Agenda Item #9

Application 2026-11-CA

Location:
153 S. Catherine Street

Summary of Request:
Replace thirteen existing wood windows with vinyl sash windows.

North side of house

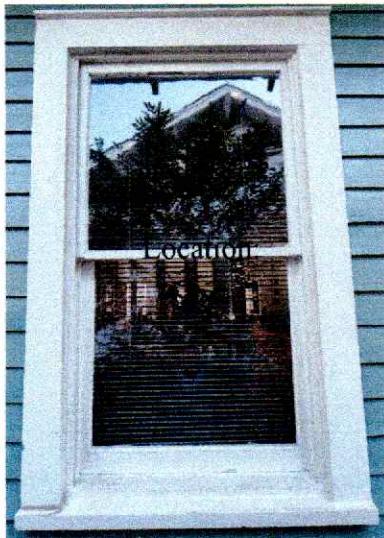
Window Component	Description of Issue/Problem
FRAME	original glass offers no insulation from sound or weather. During snow- storm, my house dropped below 40°
Sill	inside when floor pump
Jambs	broke + you could feel breeze from windows,
Exterior trim & stops	
Interior trim & stops	
Interior wall surface

north side of house

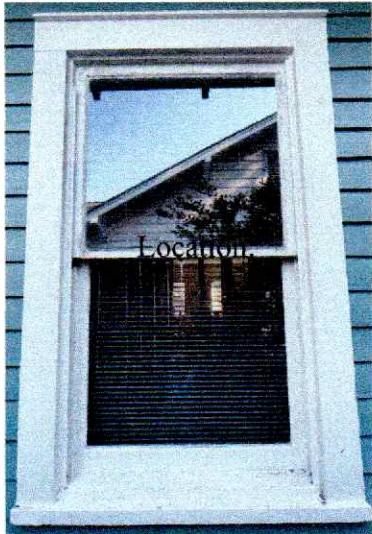
Description of Conditions: *Original glass offers no insulation from sound + weather*

FUNCTION	
Handles	
Movement mechanics	<i>unable to open even though it's the one not painted shut</i>
Locks	
“Square”	
Weatherstripping

with side kitchen window

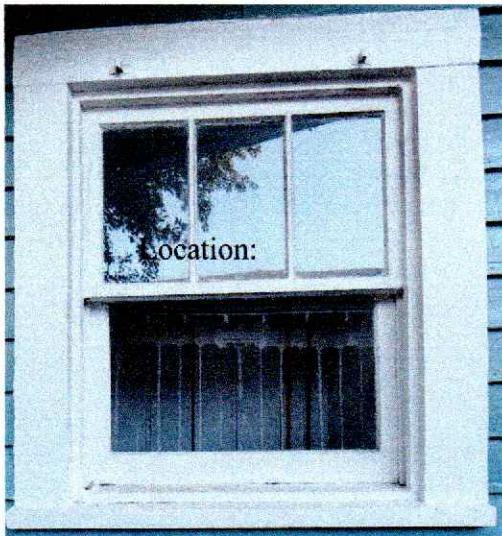
breeze + bugs come through bottom - had to cover with a towel in winter + put a bug trap in kitchen

FUNCTION	
Handles	
Movement mechanics	
Locks	
"Square"	not square
Weatherstripping	no lock, moves back & forth but difficult to open

north side
laundry room

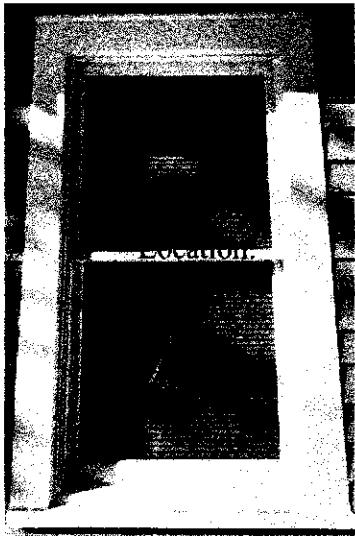
Original glass provides no insulation
from sound & weather

FUNCTION	
Handles	
Movement mechanics	
Locks	
“Square”	
Weatherstripping	Difficult to open, breeze + dust comes through bottom due to poor fit

south side of house

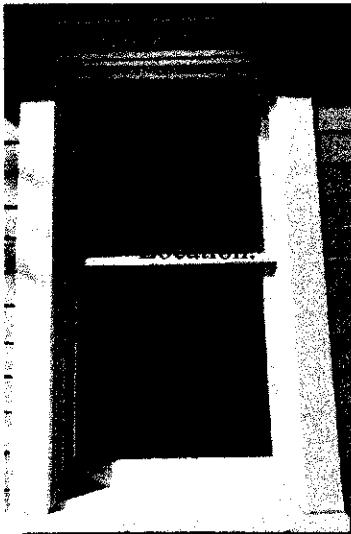
original glass reflects no insulation from
sound & weather

FUNCTION	
Handles	
Movement mechanics	
Locks	no lock - painted shut
“Square”	
Weatherstripping

South side of house

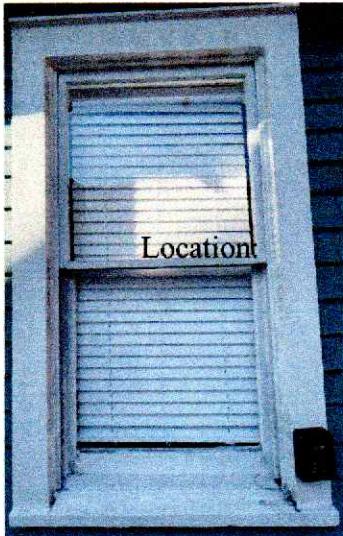
Description of Conditions: *original glass offers no insulation from sound or weather*

FUNCTION	
Handles	
Movement mechanics	
Locks	
“Square”	<i>painted shut - no lock</i>
Weatherstripping

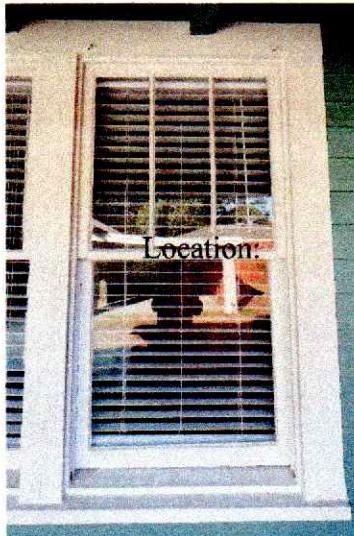
*original glass offers no insulation
from sound & weather*

FUNCTION	
Handles	
Movement mechanics	
Locks	
“Square”	<i>painted shut - no lock</i>
Weatherstripping
